ADDENDA 2

Subject: Bid 20-042 Bailey Detention Pond Improvements for the County of El Paso

AMENDMENT No. A001

THE COUNTY OF EL PASO BAILEY DETENTION POND IMPROVEMENTS **BID No. 20-042**

C2.

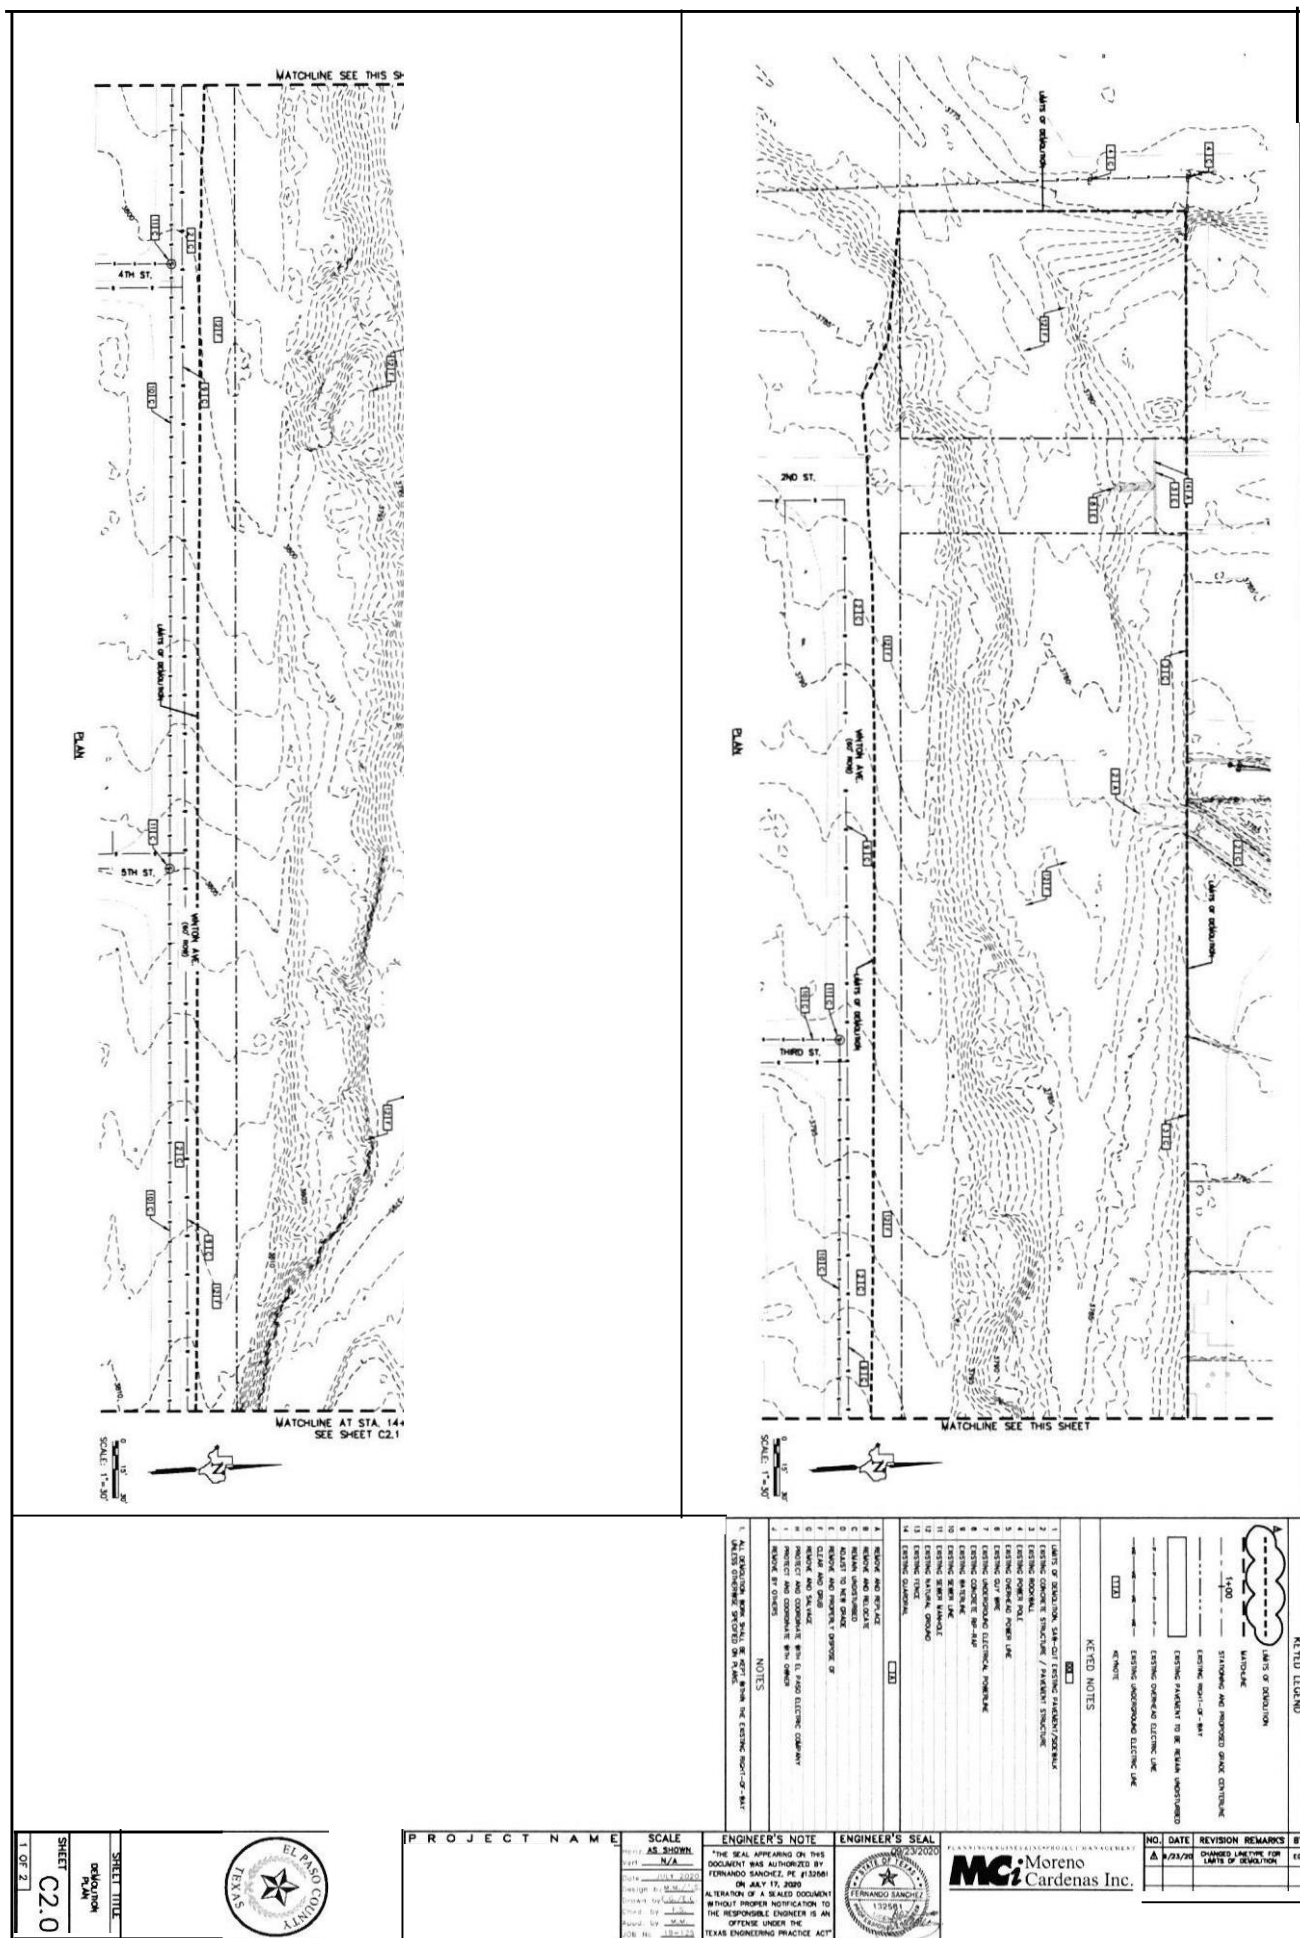
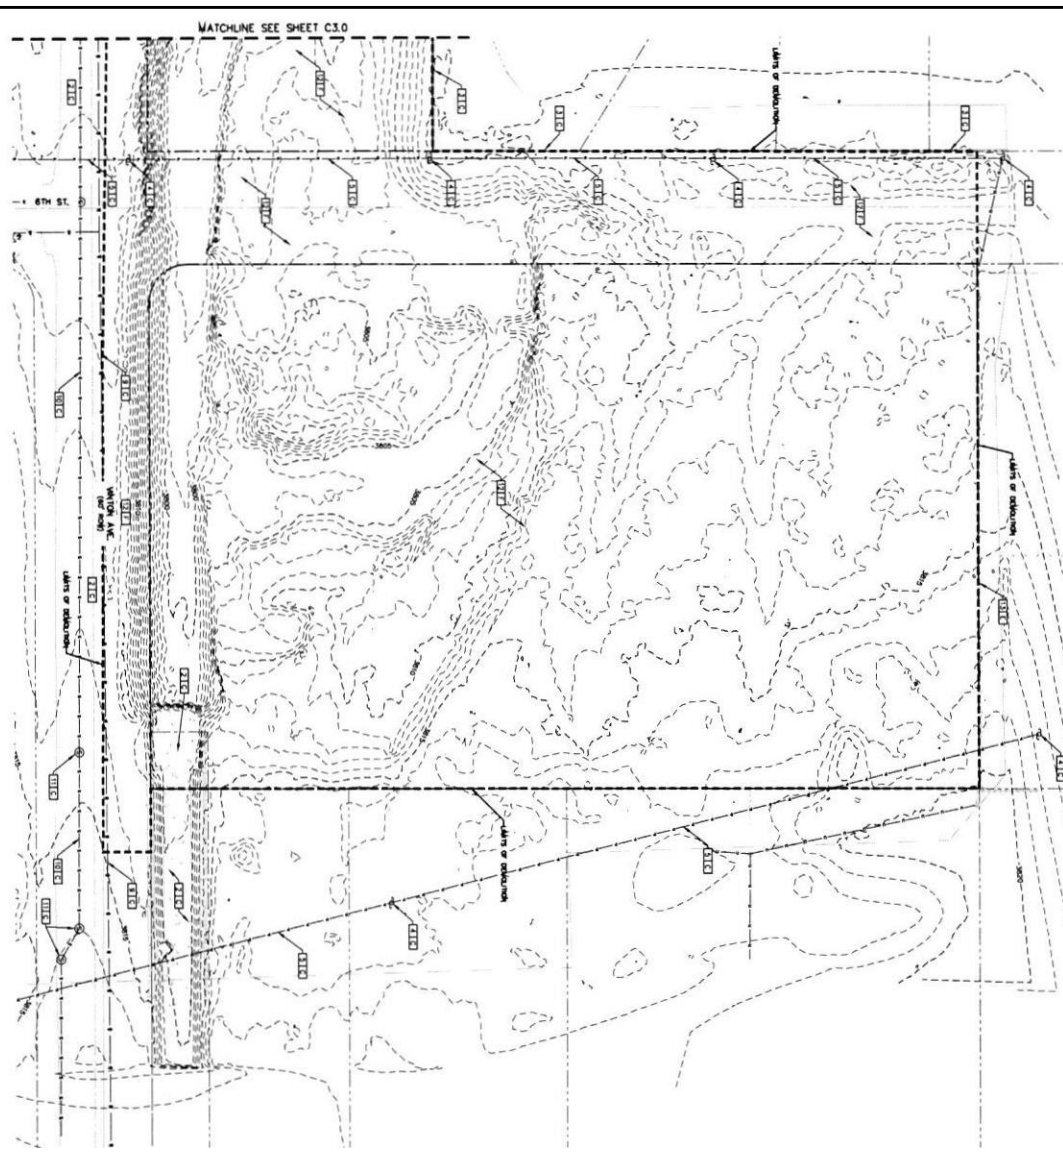
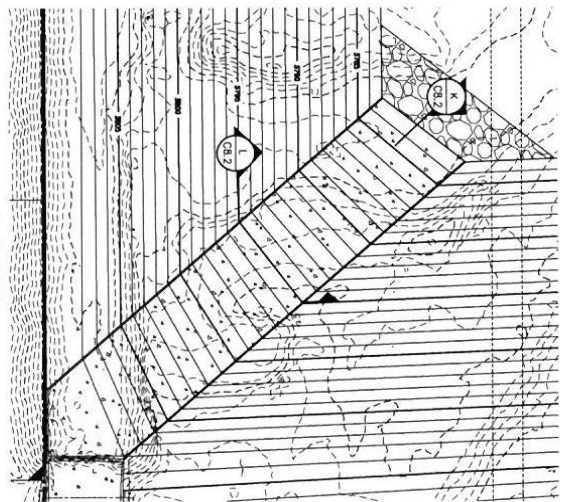
11. On the plans, match lines are confusing with the project limits on C2.0. Could the County specify what the legend are?

Response: Refer to amendment for plan sheet C2.0 and C2.1 Demolition Plan.

5. LOOSE ROCK RIP-RAP DETAIL
SCALE 1/2\"/>

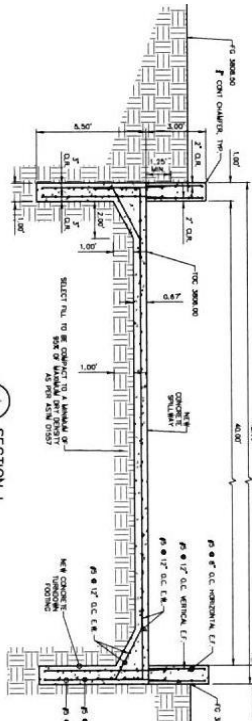
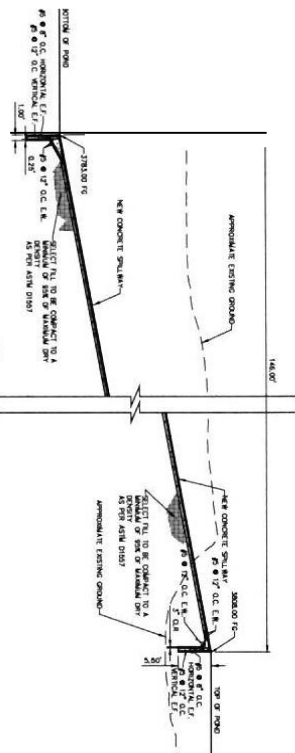
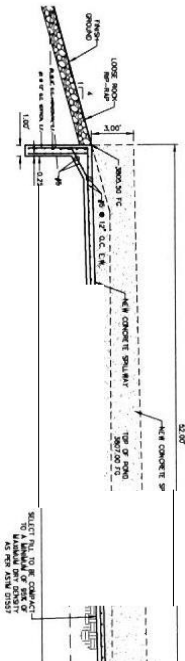
19. Section 37 37 00 and Plan Sheet C8.2 Detail 5 are asking for 6"-8" rock rip rap, but Bid Item #1 is asking for 8"-12" rock rip rap. What is the correct rock size needed for this project?

Response: Rip-rap must be 8-inch minimum and 12-inch maximum size. See Rip Rap amendment for Section 31 37 00 of technical specifications and plan sheet C8.0 Drainage Details.

6. BASE COURSE
SCALE 1/2\"/>

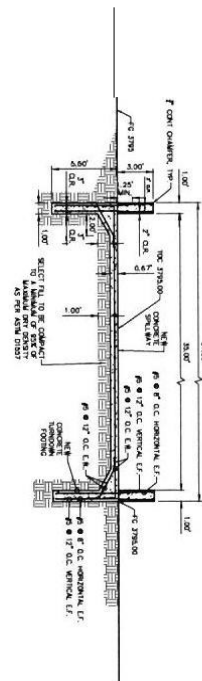
20. There was no specification found regarding the base course material. Could the County identify and confirm TXDOT Item 247 Type A Grade 3 Base Course per Bid Item #1?

Response: Flexible base course must be crushed stone base course Type A, Grade 1-2 conforming to TxDOT Standard Specifications 2014, Item 247 – Flexible Base. See Amendment.

SHEET		SHEET TITLE		PROJECT NAME		SCALE		ENGINEER'S NOTE		ENGINEER'S SEAL		PLANNING ENGINEER/PROJECT MANAGER		NO. DATE REVISION REMARKS BY		
C8.2		DRAINAGE DETAILS		BAILEY DETENTION POND IMPROVEMENTS		1/8"=1'-0"		THE SEAL AFFIXED ON THIS DOCUMENT WAS AUTHORIZED BY FERNANDO SANCHEZ, PE #125961 ON JULY 17, 2020				 Moreno Cardenas Inc.		CHANGED BASE COURSE FROM 6" TO 8" - 1' 6"		68
3 OF 3								ALTERNATION OF A SEALED DOCUMENT WITHOUT PROPER NOTIFICATION TO THE RESPONSIBLE ENGINEER IS AN OFFENSE UNDER THE TEXAS ENGINEERING PRACTICE ACT				2007 E. Missouri Ave. 11700 Fort Worth, TX 76116 (817) 339-9261 9401 McAllister Freeway #207 Fort Worth, TX 76120 (817) 339-1333 Texas Board of Professional Engineering Registration No. 24869534		CHANGED BASE COURSE FROM 4" TO 6" - 1' 6"
